STATE OF CONNECTICUT
CONNECTICUT SITING COUNCIL

IN RE:	:	
	:	
APPLICATION OF CELLCO	:	DOCKET NO. 495
PARTNERSHIP D/B/A VERIZON	:	
WIRELESS FOR A CERTIFICATE OF	:	
ENVIRONMENTAL COMPATIBILITY AND	:	
PUBLIC NEED FOR THE CONSTRUCTION,	:	
MAINTENANCE AND OPERATION OF A	:	
WIRELESS TELECOMMUNICATIONS	:	
FACILITY AT 5151 PARK AVENUE IN	:	
FAIRFIELD, CONNECTICUT	:	FEBRUARY 11, 2022

MOTION TO REOPEN THE EVIDENTIARY HEARING AND MODIFY
THE DECISION DUE TO CHANGED CONDITIONS

Approved, Proposed, and Temporary
 Wireless Telecommunications Facilities
 Plattsville Relo CT
 5151 Park Avenue
 Fairfield, Connecticut

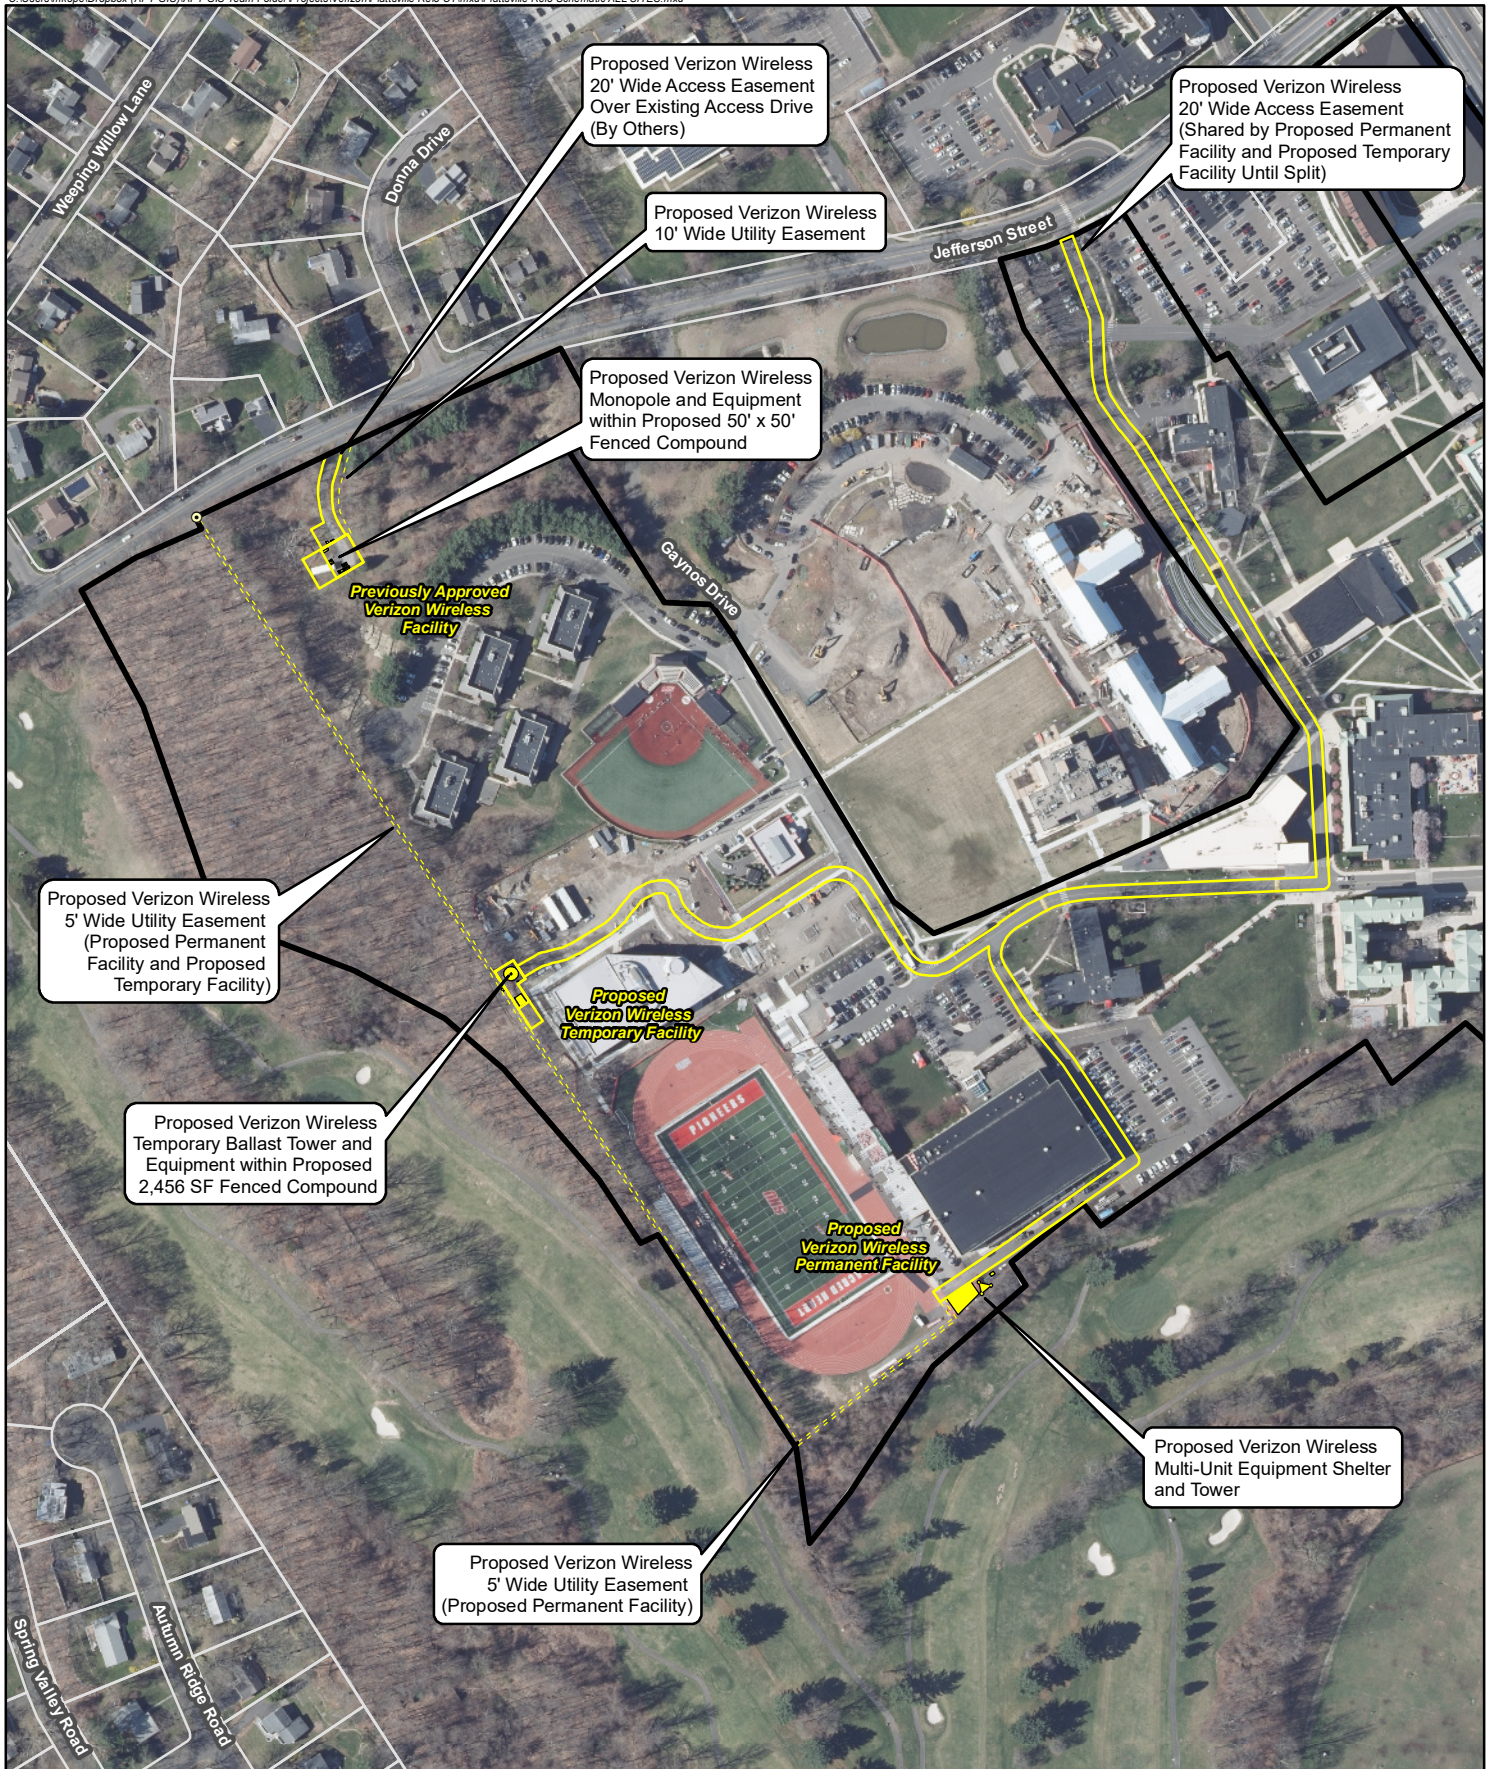
determined that an alternate tower site located near the southwest corner of the Pitt Recreation Center (the “Pitt Center”) and south of the SHU football field was acceptable to SHU and Cellco (the “Alternate Facility”).¹ (See Docket No. 495 Application, Attachment 8, Site 2B). As discussed in the Application, a tower of appropriate height at this location would satisfy Cellco’s wireless service objectives at SHU and the surrounding area including portions of the Merritt Parkway.

Cellco now asks the Council to reopen the Docket No. 495 evidentiary proceeding and reconsider and approve the relocation of the Docket No. 495 tower site from the location approved in Docket No. 495, to Alternate Site Location 2B, in the southwest portion of the Property. As discussed in more detail below, this alternative tower location will provide Cellco customers with wireless service comparable to the Proposed Facility, will result in significantly less visual impact to residential areas to the north and west of the Property and will not have a significant adverse environmental effect. Attached hereto as Exhibit 1 is a Site Schematic map showing the southwest portion of the SHU Main Campus, the Docket No. 495 approved tower location, the location of the temporary tower location approved by the Council in Petition No. 1470 and the proposed alternative tower location at the southwest corner of the Pitt Center on the SHU Main Campus.

SHEET TITLE
COMPOUND PLAN

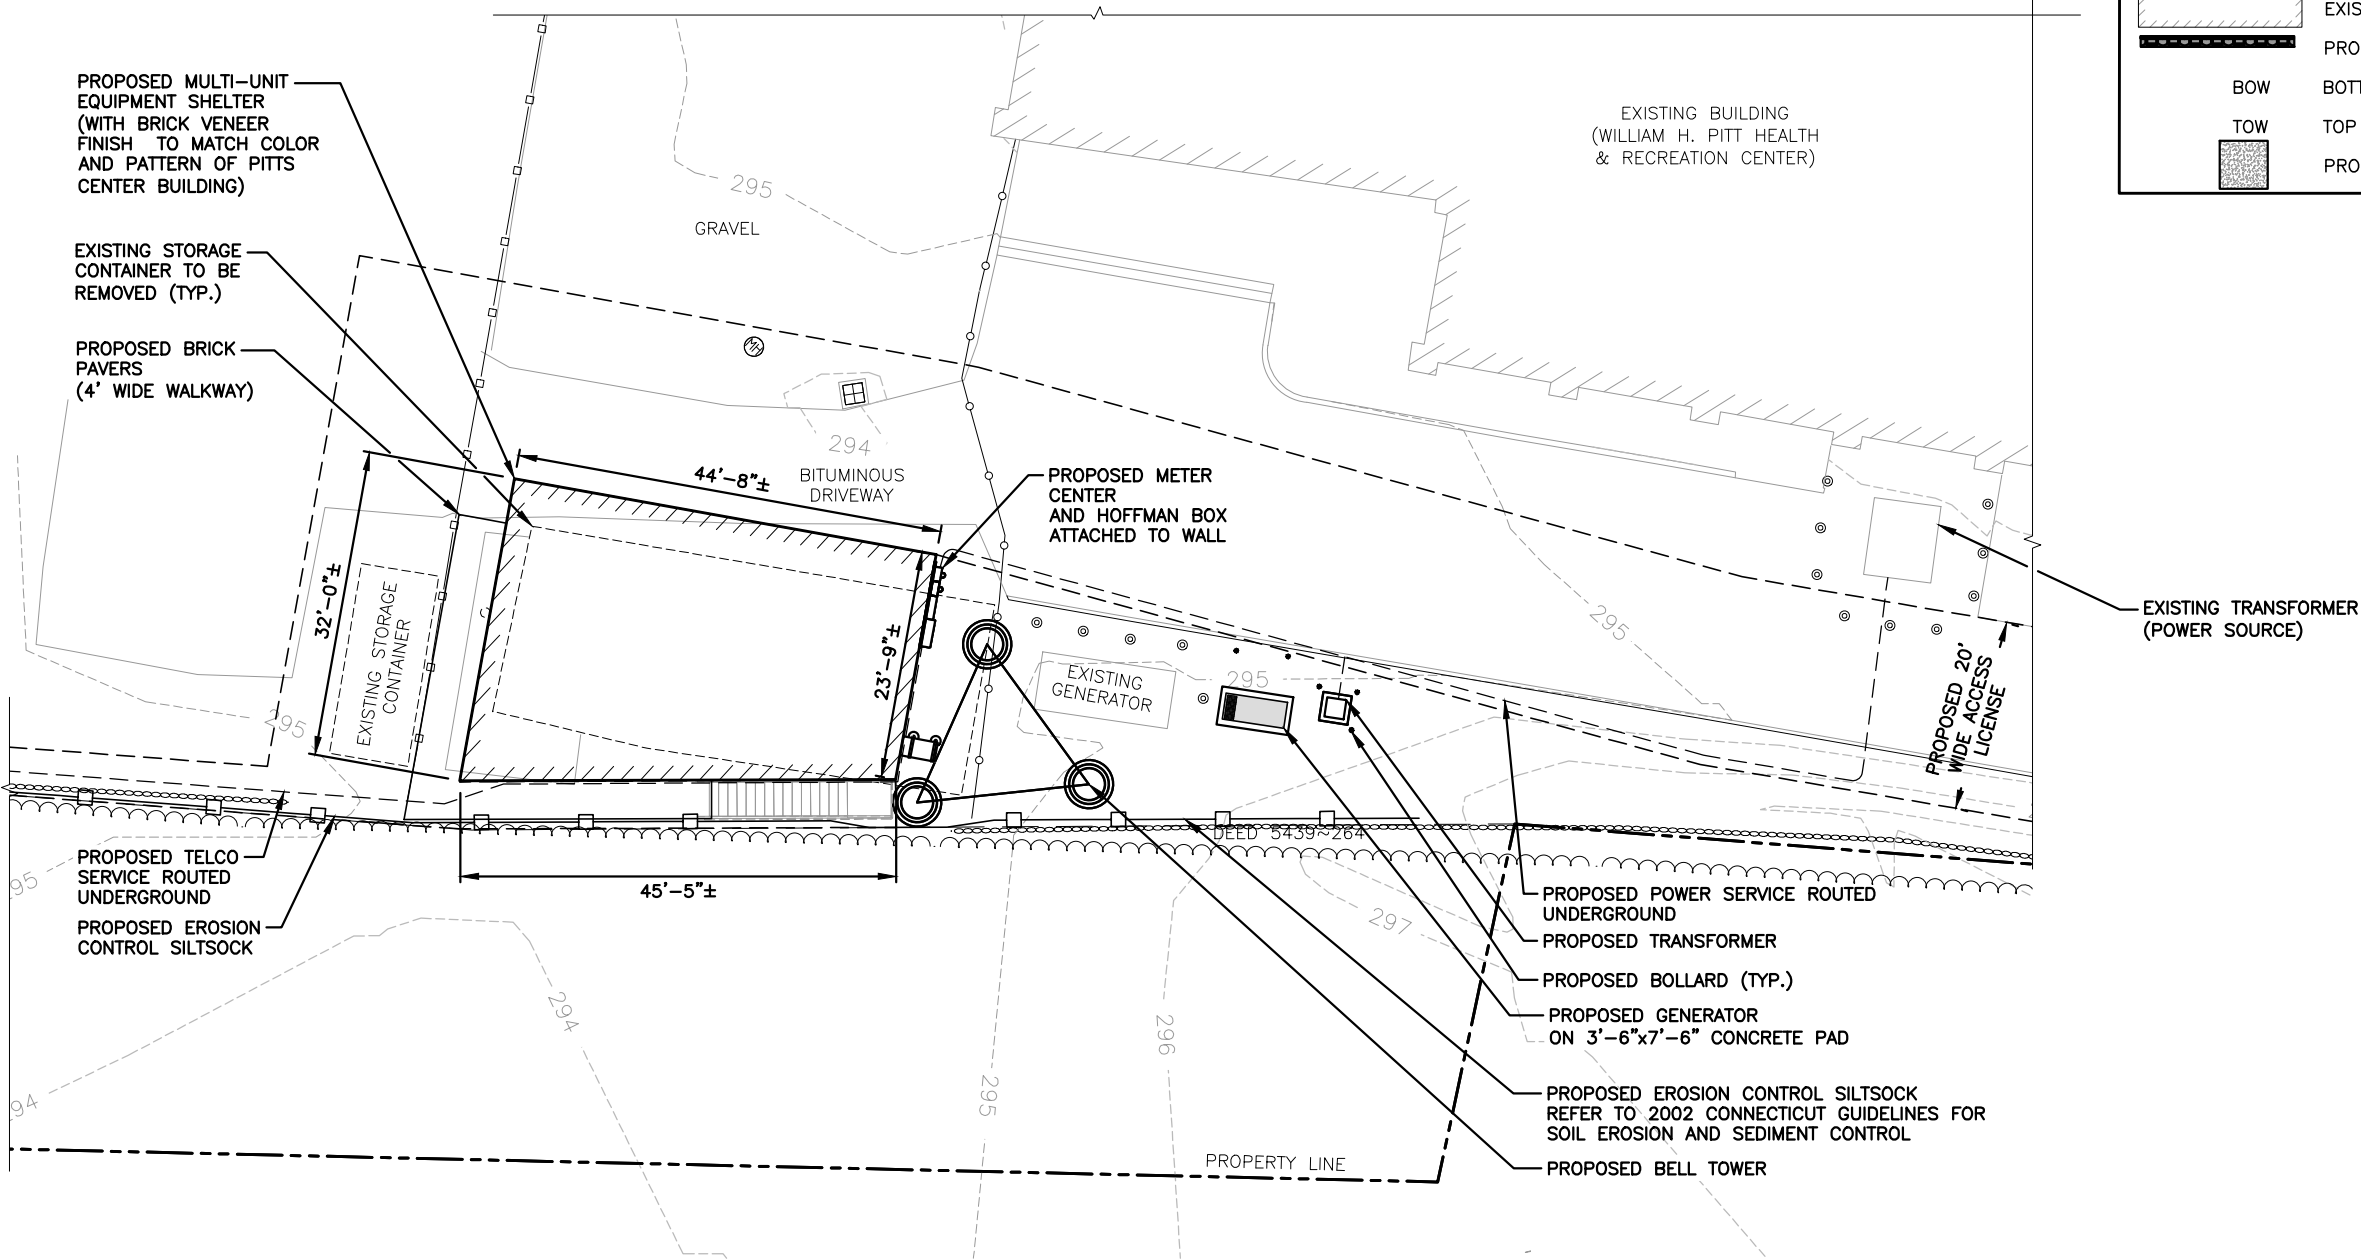
The Alternate Facility would be located within an irregularly-shaped facility compound near the southwest corner of the Pitt Center. At this location, Cellco would construct a telecommunications tower, disguised as a decorative bell tower and a 1,245 square foot two-story

equipment shelter with separate rooms for Cellco, AT&T and T-Mobile wireless equipment. Excess storage space within the shelter would be utilized by SHU.

SHEET TITLE
**ELEVATION AND
ANTENNA PLAN**

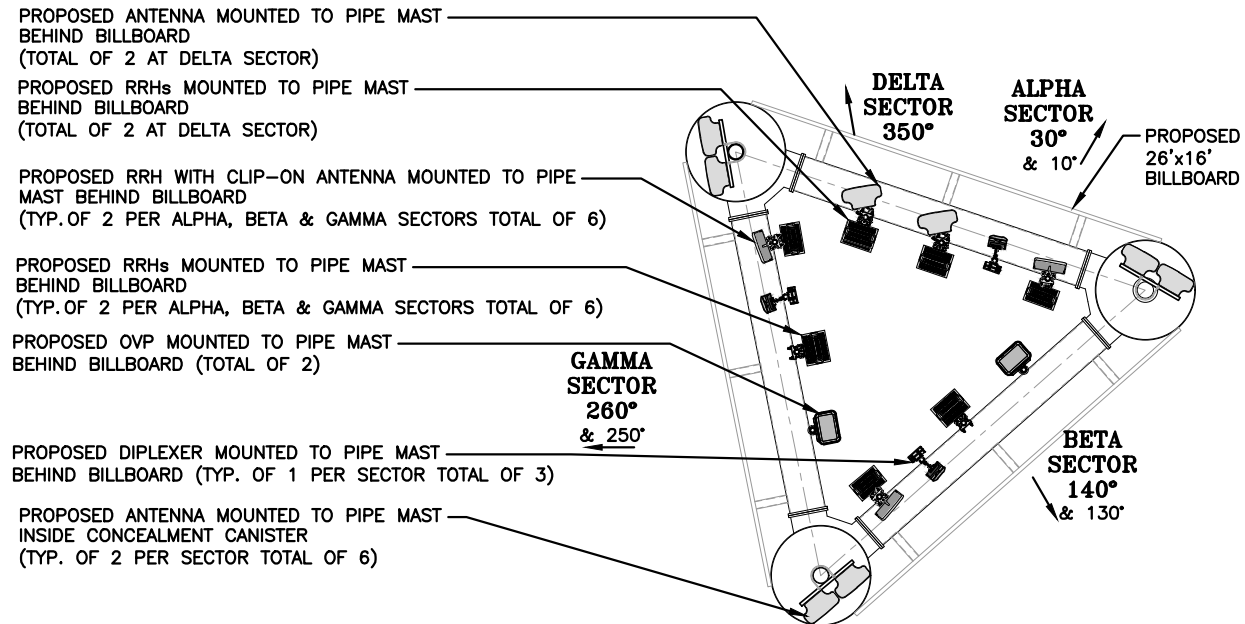
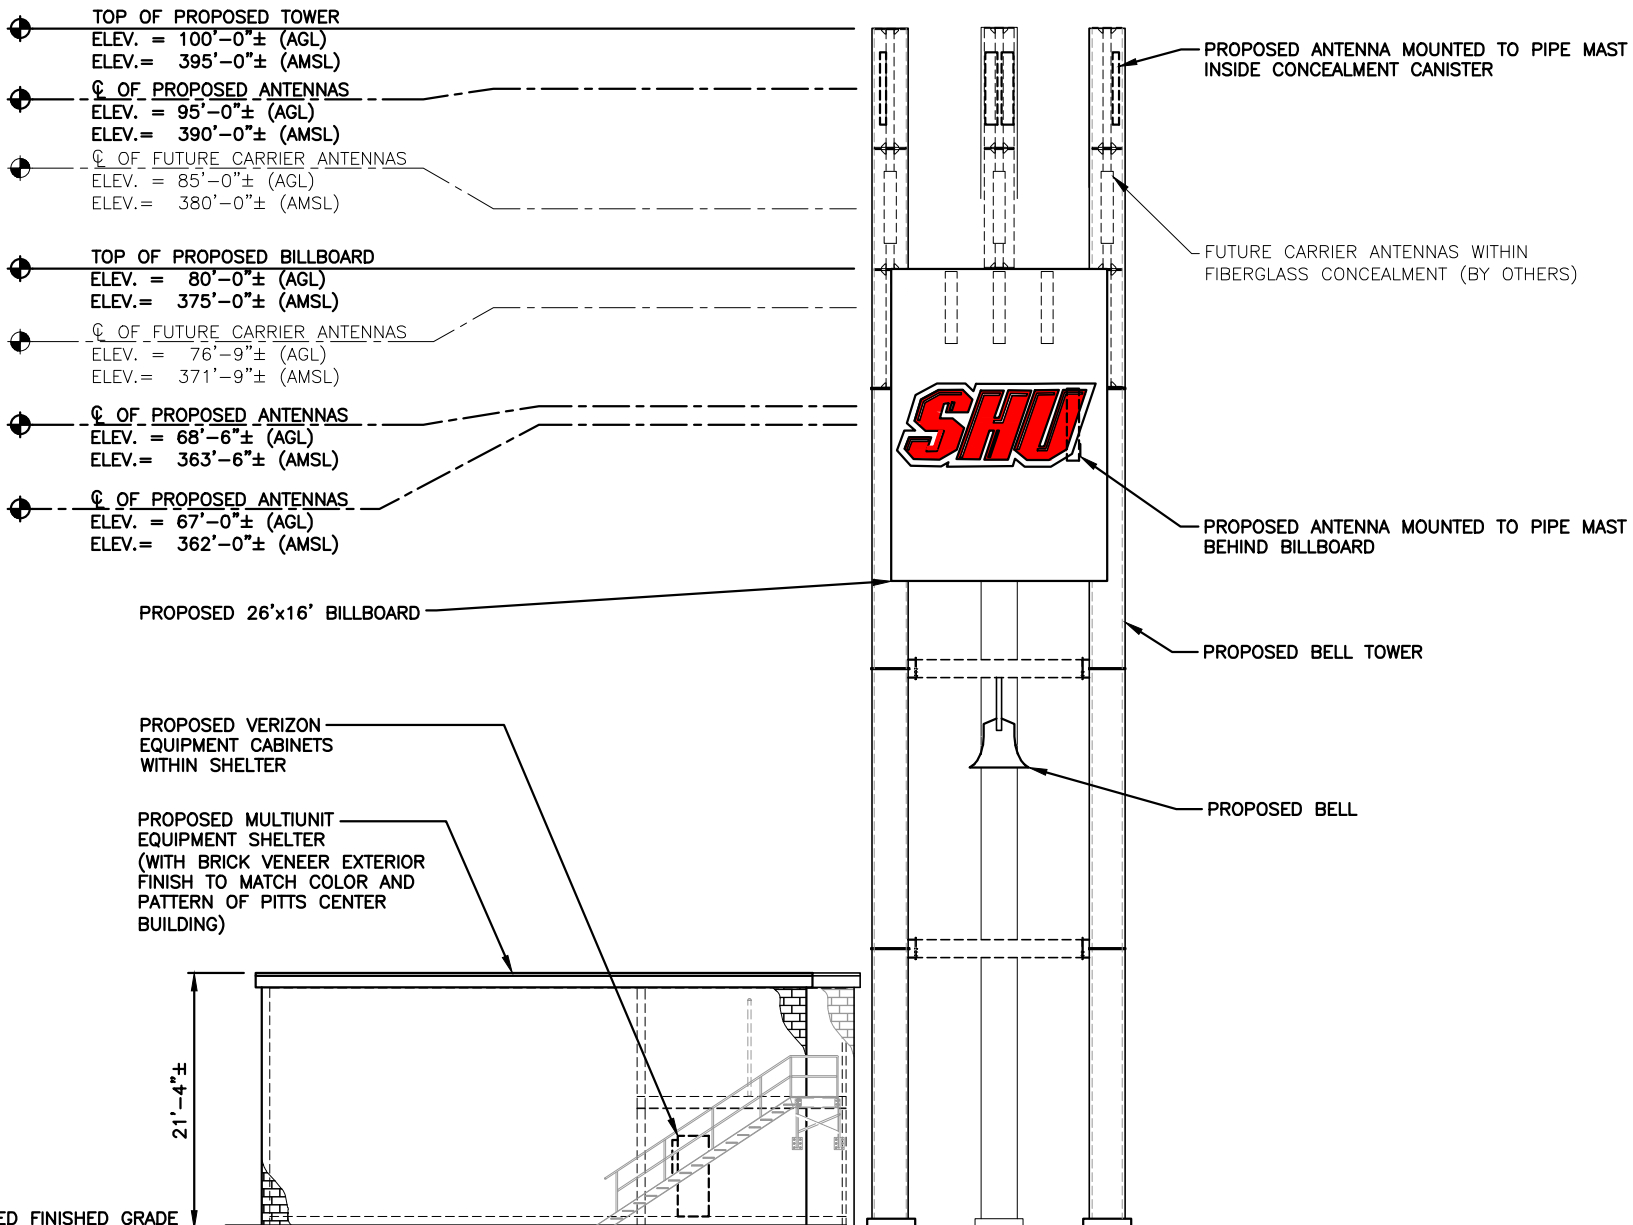
Cellco will install eight (8) antennas on a triangular antenna platform at a height of 68.5 feet above grade and six (6) antennas at a height of 95 feet above grade, inside the top portion of the three (3) uni-poles that support the bell tower (two antennas inside each unipole). AT&T will install its antennas on a triangular antenna platform at a height of 76.75 feet above grade. Cellco's and AT&T's platform-mounted antennas will be located behind RF transparent screening panels. T-Mobile's antennas would be located inside the three (3) uni-poles supporting the bell tower at a height of 85 feet above grade. A 60-kW diesel-fueled generator will be installed on a concrete pad to the east of the proposed bell tower and will be shared by Cellco, AT&T and T-Mobile. A set of Project Plans for the Alternate Facility are attached as Exhibit 2.
